# 1. Pre-Application Conference Report

## PRE-APPLICATION MEETING NOTES

PA25-1049

<b>Applicant:</b>	AKS Engineering & Forestry LLC
<b>City of Camas:</b>	Madeline Coulter, Planner Ahmed Yanka, Engineering Brian Smith, Building Randy Miller, Fire Marshal
<b>Location:</b>	4511 NW 18TH AVE Parcel Number: 125193000
<b>Zoning:</b>	Multi-Family Residential (MF-18)
<b>Description:</b>	To construct 154 single family lots with associated stormwater facility, critical area, parking, and landscaping tracts.

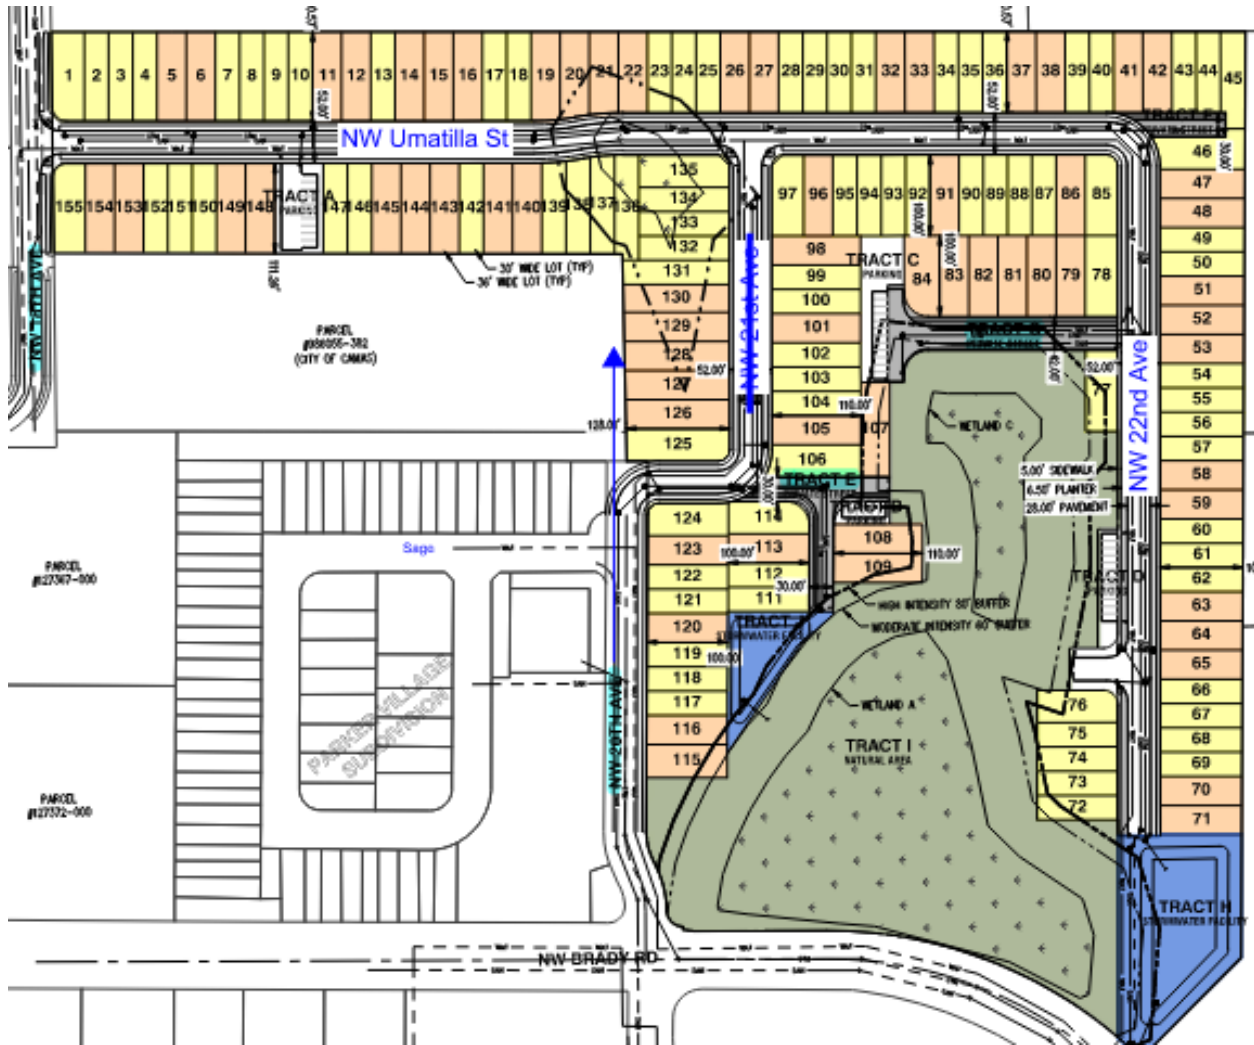
4. The TIA will be sent to the City of Vancouver (COV) Traffic Engineer for review and comments.
5. COV will require trip distributions to the following intersections for proportionate share fees.
